S E R V I C E N O T E

89430A RF Section

New power switch improves reliability**Duplicate Service Notes:**

Figure 1

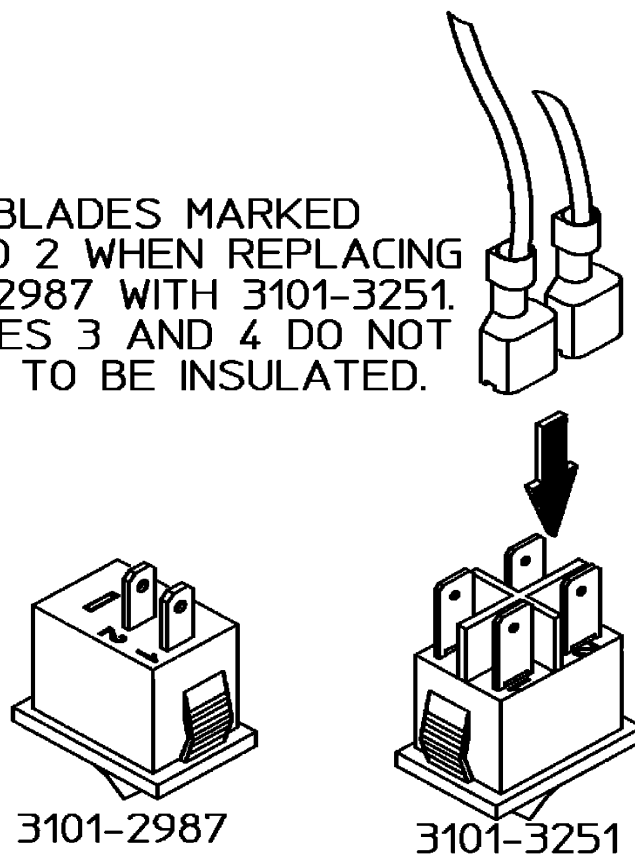
The old front panel power switch (p/n 3101-2987) has a hole which is allowing airflow through the switch. Occasionally particles also get into the switch that cause the switch to fail. The new switch (p/n 3101-3251) has no open holes for airflow. It also has additional gold plating to protect the switch mechanism from possible corrosion. The new switch is a DPST switch, with only one pole being used.

1. When installing the new switch there are four quick connect blades instead of two (as on the old switch). use the blades marked “1” and “2” on the switch at the base of the blades. See figure 1.

USE BLADES MARKED
1 AND 2 WHEN REPLACING
3101-2987 WITH 3101-3251.
BLADES 3 AND 4 DO NOT
NEED TO BE INSULATED.
